Change No. 14
License Nos. DPR-32
and DPR-37

CHANGE NO. 14 TO THE TECHNICAL SPECIFICATIONS

OPERATING LICENSES NOS. DPR-32 AND DPR-37

SAFETY EVALUATION BY THE DIRECTORATE OF LICENSING

FIGURE 6.1-1

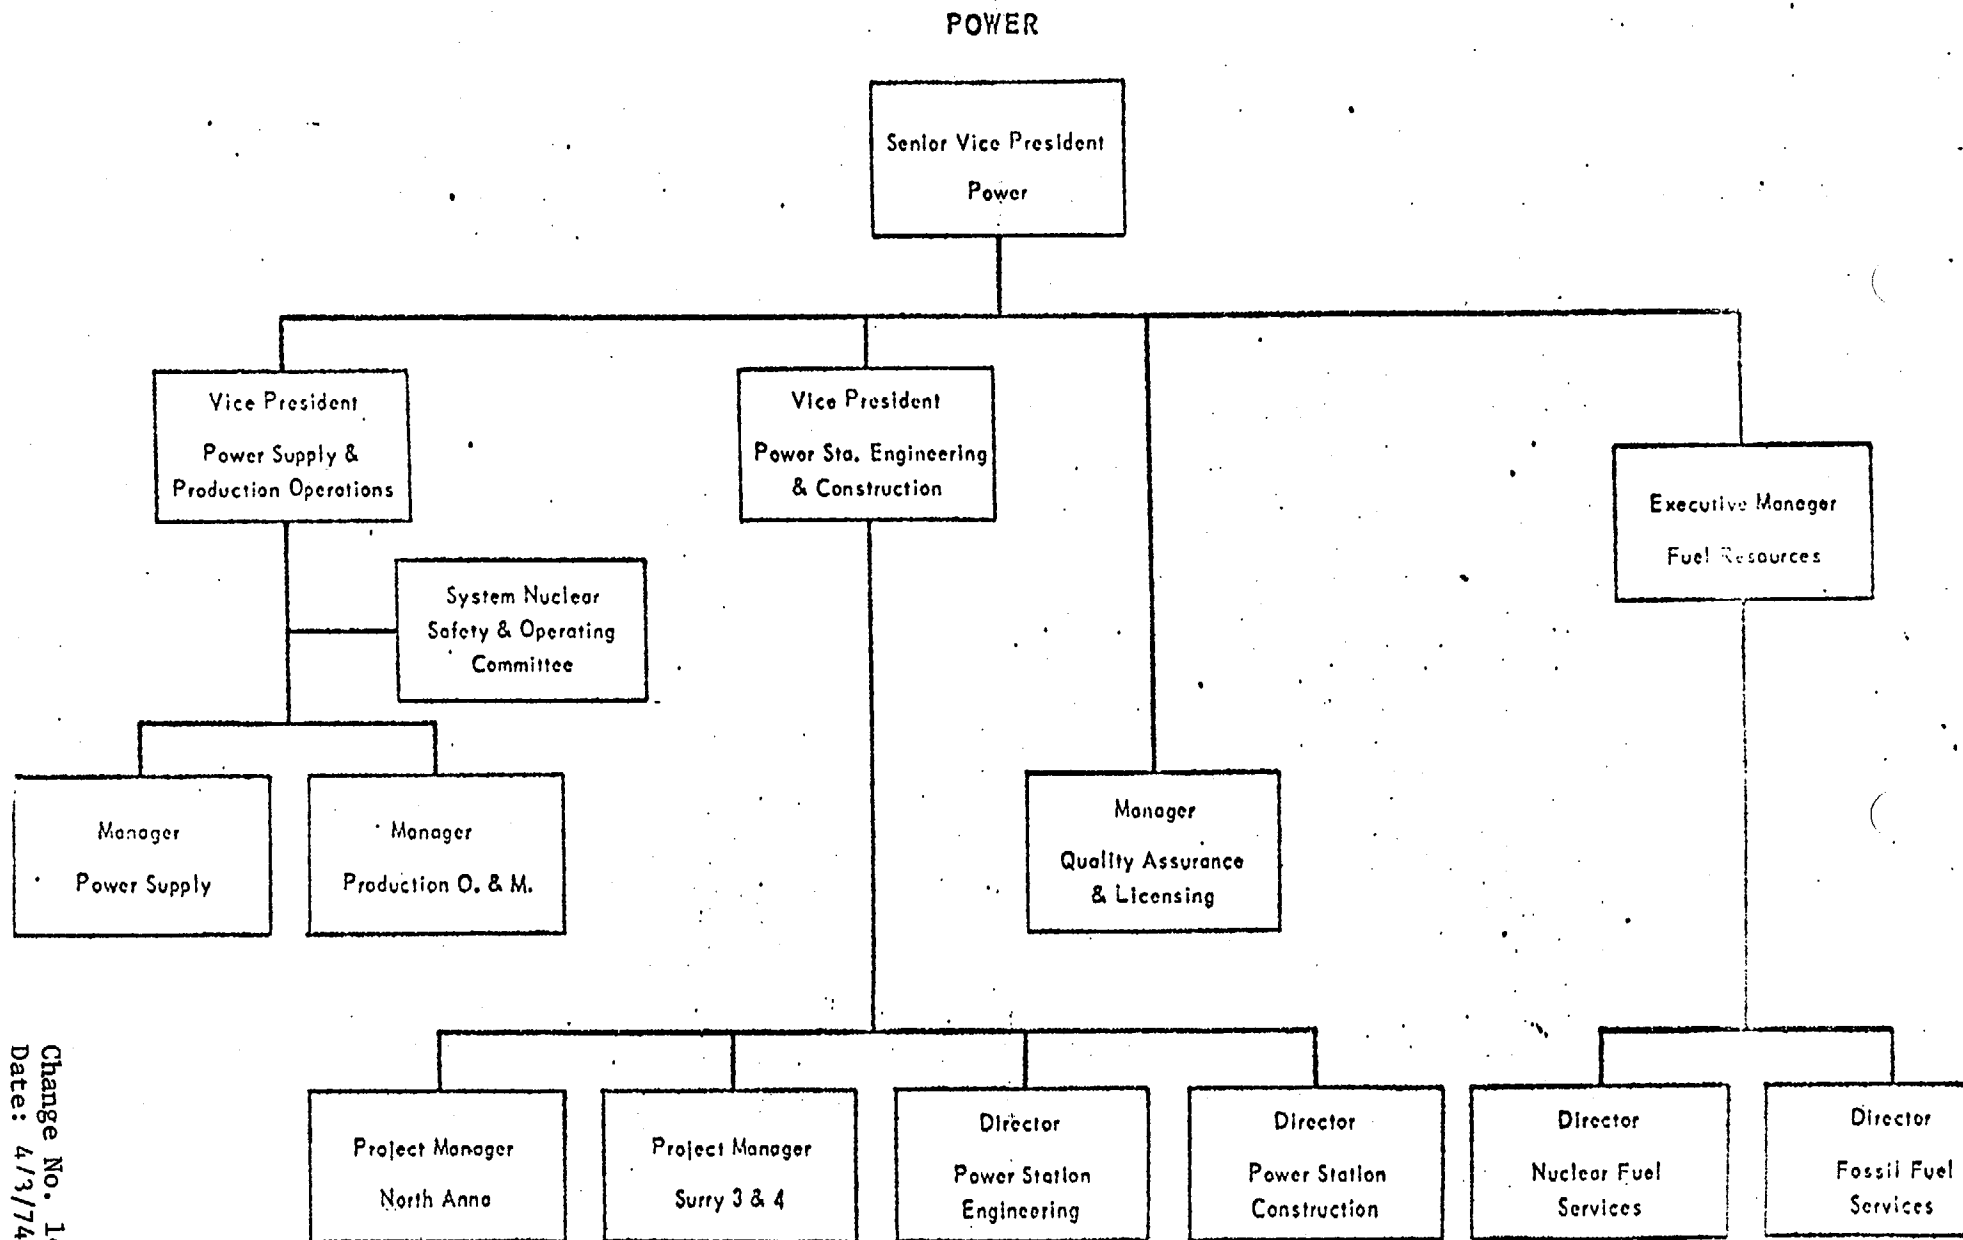
4. Replace Figure 6.1-1 with the attached figure.

The proposed changes to Section 6.1-1 reflect organizational changes that went into effect within VEPCO on January 1, 1974, and are found acceptable.
